STAFF REPORT
KETCHUM PLANNING AND ZONING COMMISSION
MEETING OF JUNE 8, 2020

PROJECT: 3020 Warm Springs Rd Duplex Design Review

FILE NUMBER: P20-031

SOUTH EXTERIOR ELEVATION

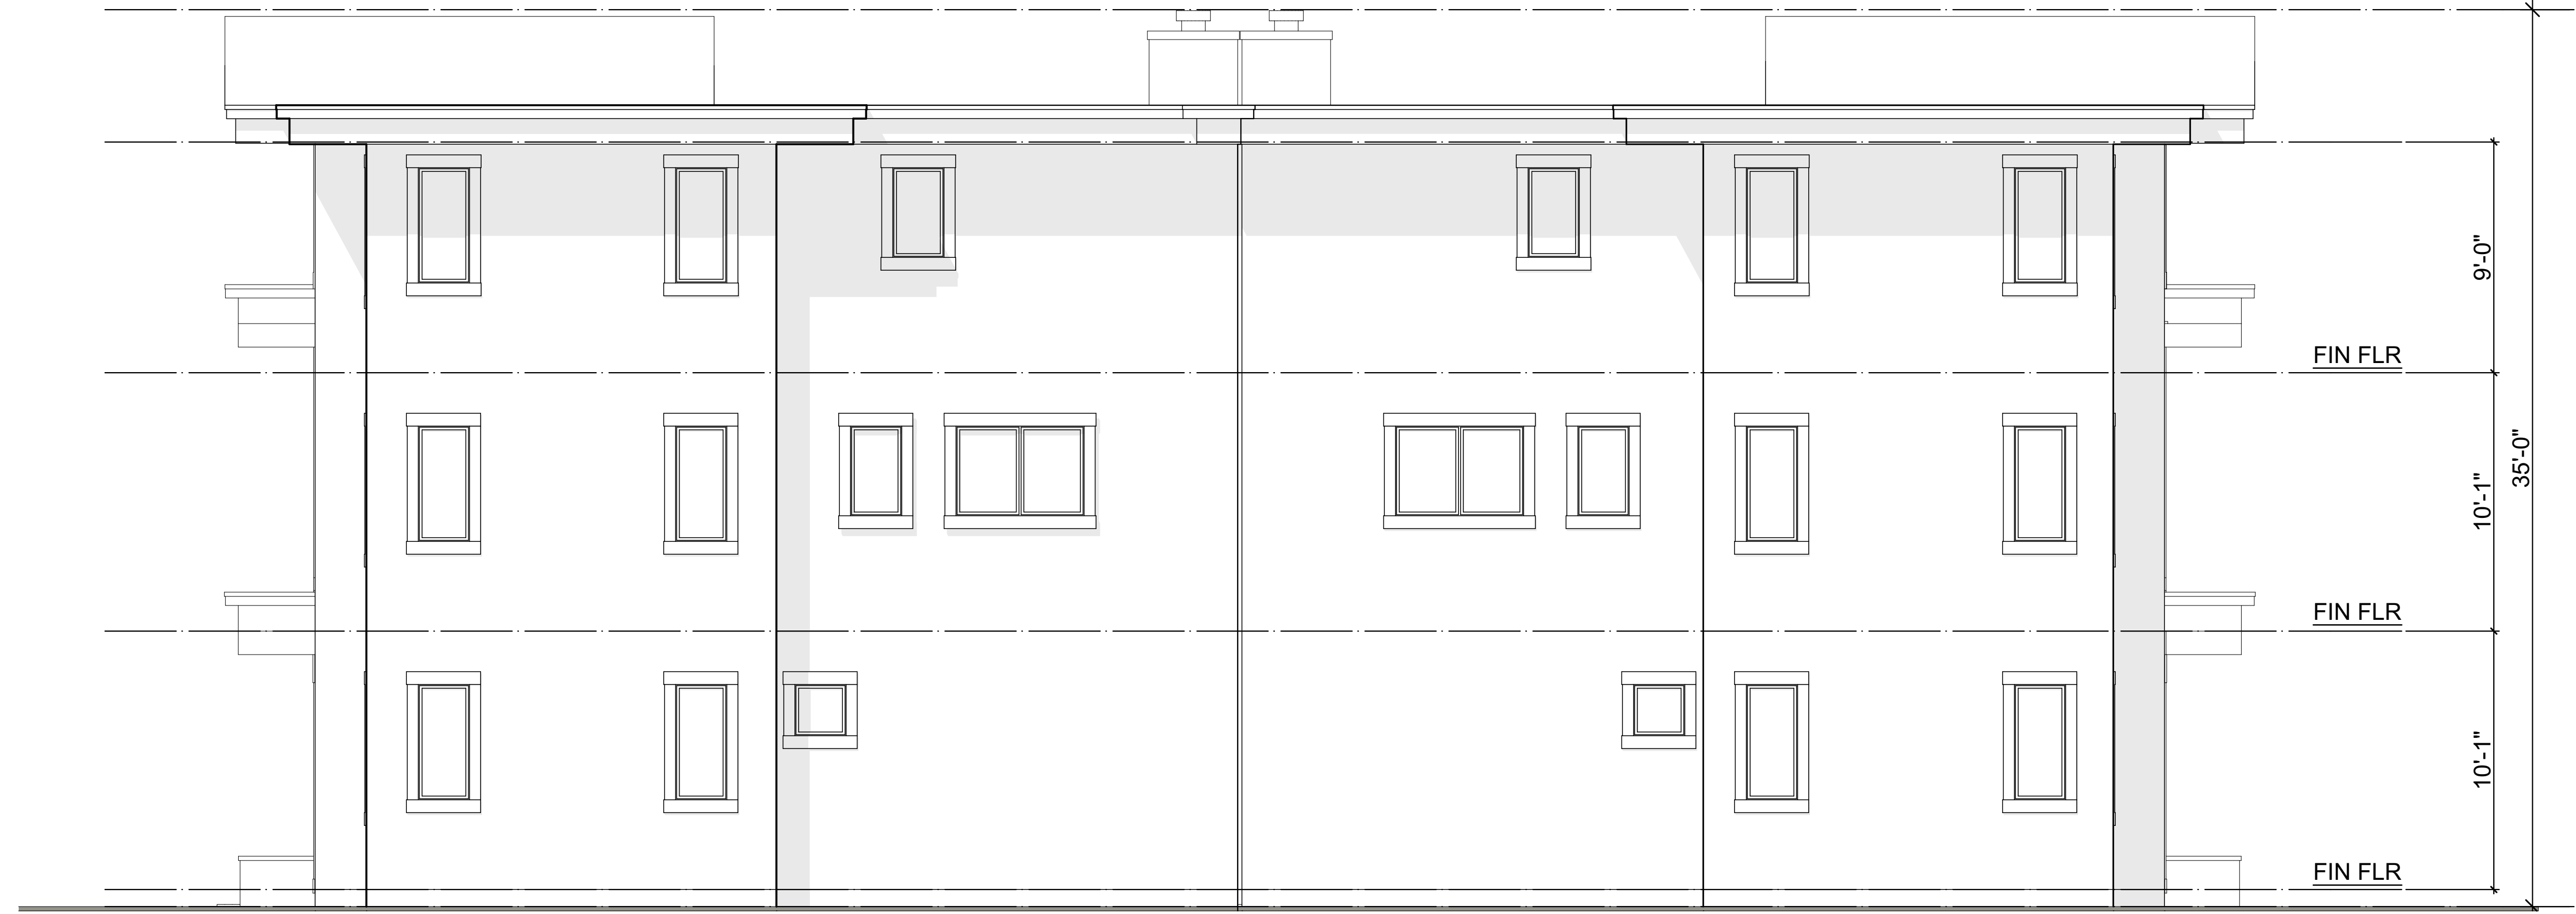
The applicant has submitted new renderings of the rear and side elevations. The applicant has enhanced material differentiation through the addition of cedar siding to the project's exterior material palette. The cedar siding contrasts with the stucco to form horizontal and vertical elements that add visual interest to the rear and side elevations. The applicant has also adjusted the pattern of windows to visually distinguish each floor level. The new renderings highlight undulations of building mass that were less apparent in the project plan elevations.

Building elevations are included on Sheets A-03 and A-04 of the project plans. The three floors are horizontally stacked on top of each other as one-story elements separated by a border of black fascia. The lack of sufficient vertical, two- or three-story elements incorporated into the façade design exacerbates the appearance of flatness.

LANDSCAPE PLAN

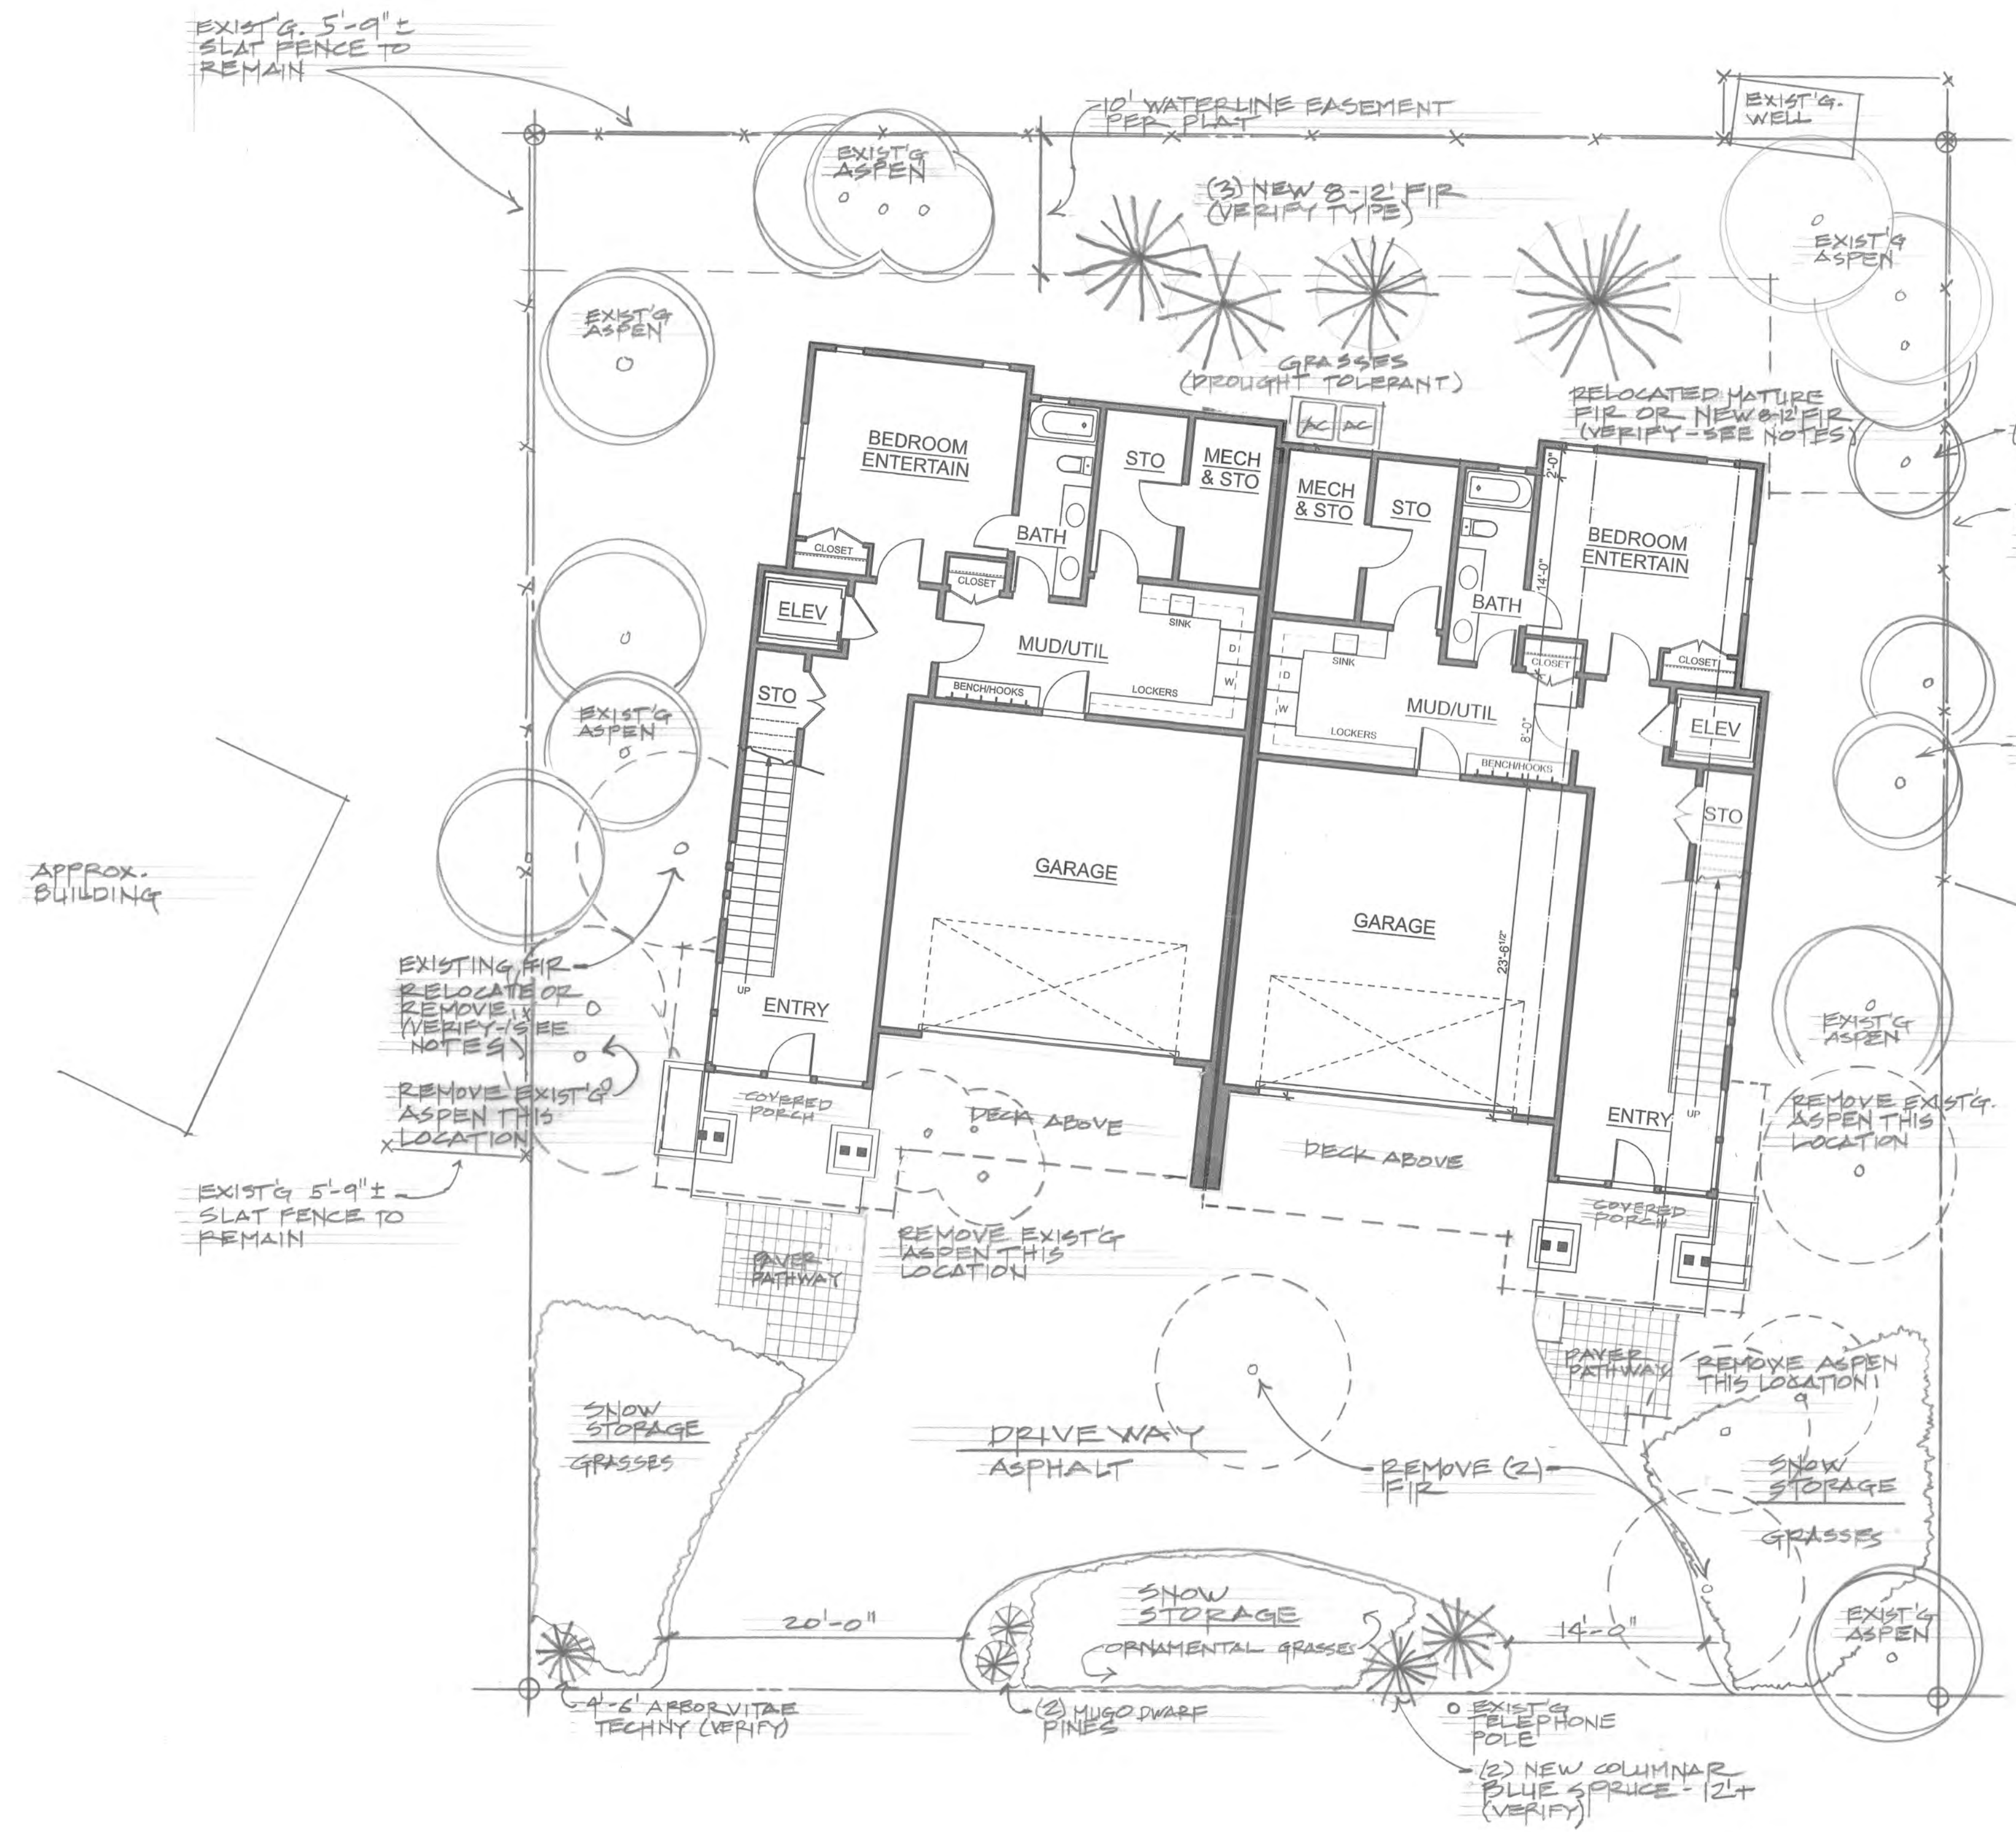
The updated landscape plan is indicated on Sheet L-01 of the project plans (Exhibit B). Three new fir trees have been added to the backyard. These coniferous trees will help soften the rectangular building mass and provide visual relief at the rear elevation. Aspen trees have been added to the side yards. The island separating the two circular driveway entrances has been enhanced with new landscape plantings. The introduction of new trees and shrubs enhances screening between neighboring properties and Warm Springs Road.

<i>Staff Comments</i>	<i>The updated landscape plan is indicated on Sheet L-01 of the project plans. Three new fir trees have been added to the backyard. These coniferous trees will help soften the rectangular building mass and provide visual relief at the rear elevation. Aspen trees have been added to the side yards. The island separating the two circular driveway entrances has been enhanced with new landscape plantings. The introduction of new trees and shrubs enhances screening between neighboring properties and Warm Springs Road.</i>
<input checked="" type="checkbox"/>	<input type="checkbox"/>	<input type="checkbox"/>	17.96.060.I2 Landscaping	Landscape materials and vegetation types specified shall be readily adaptable to a site's microclimate, soil conditions, orientation and aspect, and shall serve to enhance and complement the neighborhood and townscape.
			<i>Staff Comments</i>	<i>The landscape materials and vegetation types are indicated on Sheet L-01 of the project plans. See above analysis for KMC § 17.96.060.I1. All landscape materials and vegetation types shall be readily adaptable to the site's microclimate, soil conditions, orientation, and aspect.</i>
